<p>NEW YORK STATE OF OPPORTUNITY.</p> <p>Adirondack Park Agency</p> <p>P.O. Box 99, 1133 NYS Route 86 Ray Brook, New York 12977 Tel: (518) 891-4050 www.apa.ny.gov</p>	<p>APA Project Permit 2022-0155A</p>
<p>In the Matter of the Application of</p> <p>NEW YORK STATE ELECTRIC & GAS and NYS DEPARTMENT OF TRANSPORTATION</p> <p>Subject to Sections 814 of the Adirondack Park Agency Act and Pursuant to 9 NYCRR Part 578</p>	<p>Date Issued: May 18, 2023</p> <p>To the County Clerk: Please index this permit in the grantor index under the following names: 1. New York State Electric & Gas</p>

Adirondack Park Agency Permit 2022-0155 authorized the replacement and re-location of 10 utility pole structures and activities involving wetlands. This permit amends Permit 2022-0155, as conditioned below, to allow additional temporary impacts to wetlands resulting from construction access for Pole 57.

NYSEG
 Joint Permit Application
 Line S90
 Relocation over
 Raquette Lake South Inlet
 Arietta, NY

Erosion and Sediment Control Plan
 FIGURE 7
 Page 2 of 2
 Labella Project No. 2190583 286
 Date: Aug 2023

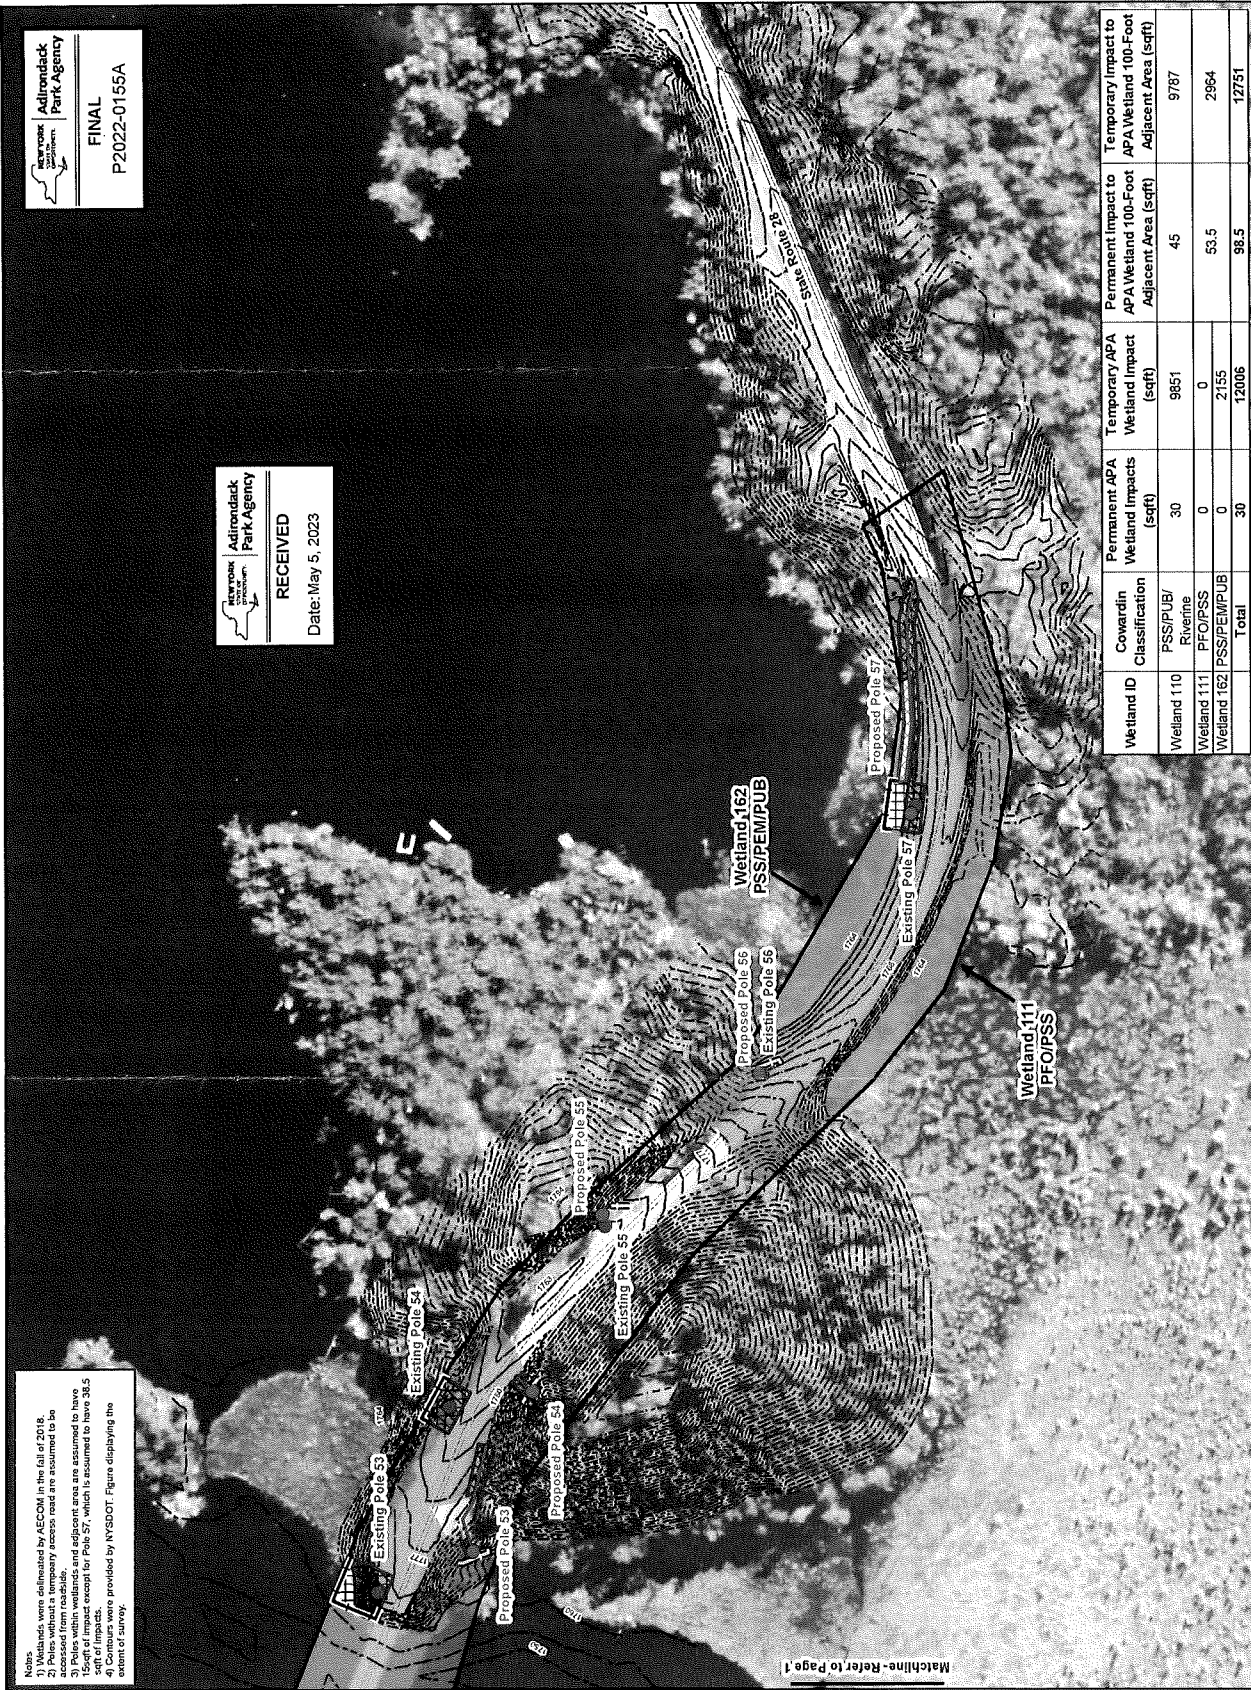
The amendment authorized herein is shown on Page 2 of the "Erosion and Sediment Control Plan, Figure 7," prepared by LaBella and dated May 2023 (Page 2). A reduced-scale copy of the Erosion and Sediment Control Plan is attached as a part of this permit for easy reference. The original, full-scale maps and plans described in this paragraph are the official plans for the project, with copies available upon request from Adirondack Park Agency headquarters in Ray Brook, New York.

1. Condition 9 of Permit 2022-0155 is hereby amended to authorize the additional temporary impacts to wetlands for access to Pole 57 in the location shown and as depicted on the Erosion and Sediment Control. Any change to the location, dimensions, or other aspect of the authorized activities shall require prior written Agency authorization.
